March 7, 2025

Re: Structural Visual Review of EnviroSystems Building at 23 E Fine Dr in Flagstaff, AZ

Figure 1 - South Basement Wall Deterioration

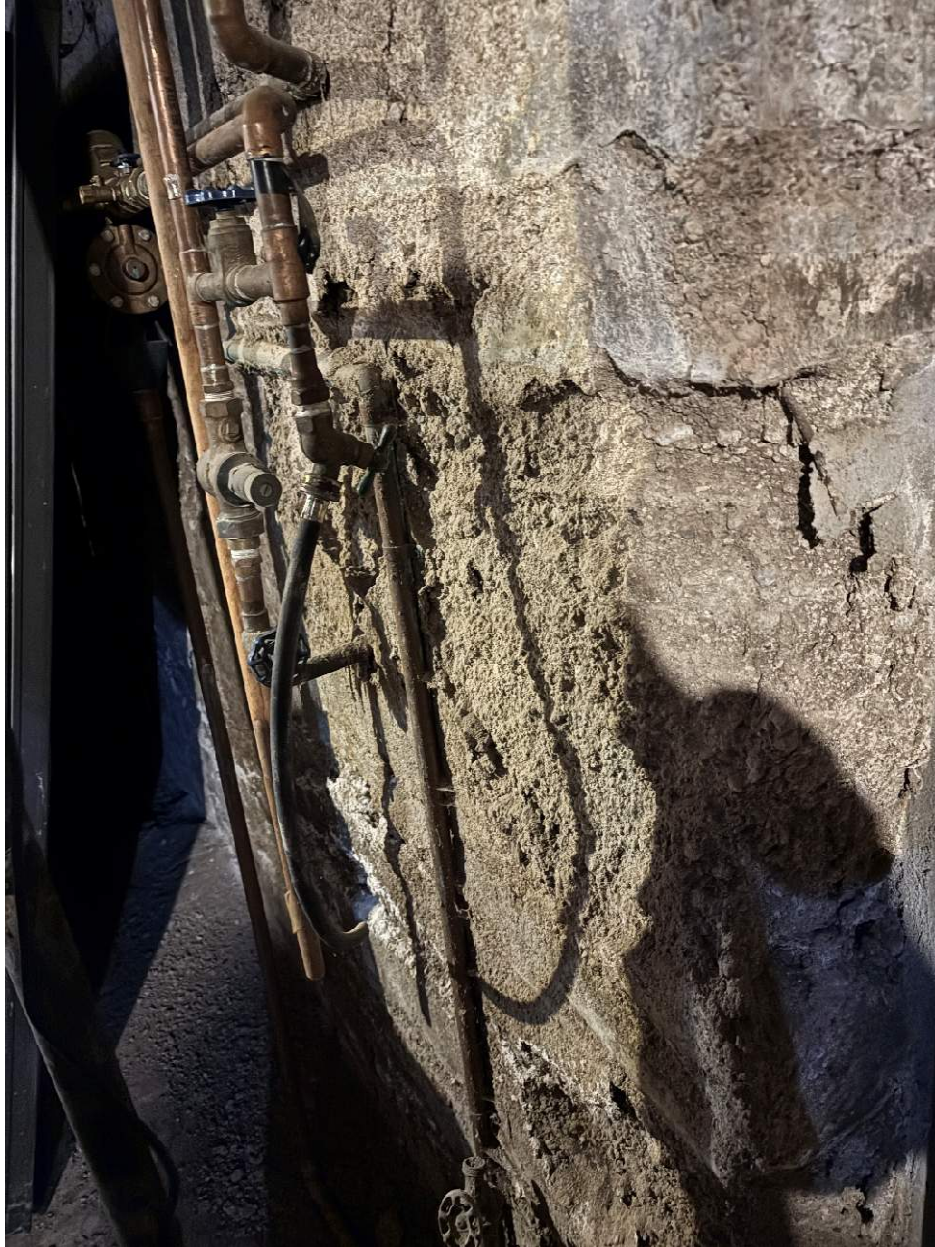
We observed signs of deterioration at the south basement retaining wall, see Figure 1 and 2. We observed a crack in the south basement wall in the area that appears to have been previously infilled. This crack, which appears to be a flexural crack due to overloading, as is shown in Figure 3. The exterior basement entrance walls have significant signs of deterioration, as shown in Figure 4. The basement entrance does not appear to be properly waterproofed and daylight is visible through the hatch.

The majority of structural deterioration and signs of distress observed are located on the south basement wall. It appears that at one point in time there was an addition and likely basement to the south of the southern basement wall. It appears that a door to the previous basement was infilled, and soil was added where it seems the previous basement likely was. It is possible that the concrete wall previously was not retaining any soil and when the suspected basement to the south of the existing southern basement wall was removed and replaced with soil, the loads on the current south basement wall increased significantly due to the added soil pressure, which may be a potential cause of structural distress we observed from the interior of the basement. A couple of other potential causes of the deterioration in the south wall, specifically at the south eastern corner (Figure 2), could be a poor concrete mix in that specific location and/or water intrusion. We recommend the entire south basement wall be reinforced and/or replaced and recommend waterproofing be installed on the exterior of the walls in order to prevent further deterioration of the existing walls. In order to minimize disruptions to the existing building, one potential option to reinforce the existing south basement wall could be to add a new concrete wall on the exterior of the building adjacent to the existing. The new wall would be connected to the existing wall and would be designed as a retaining wall to resist the soil pressures.
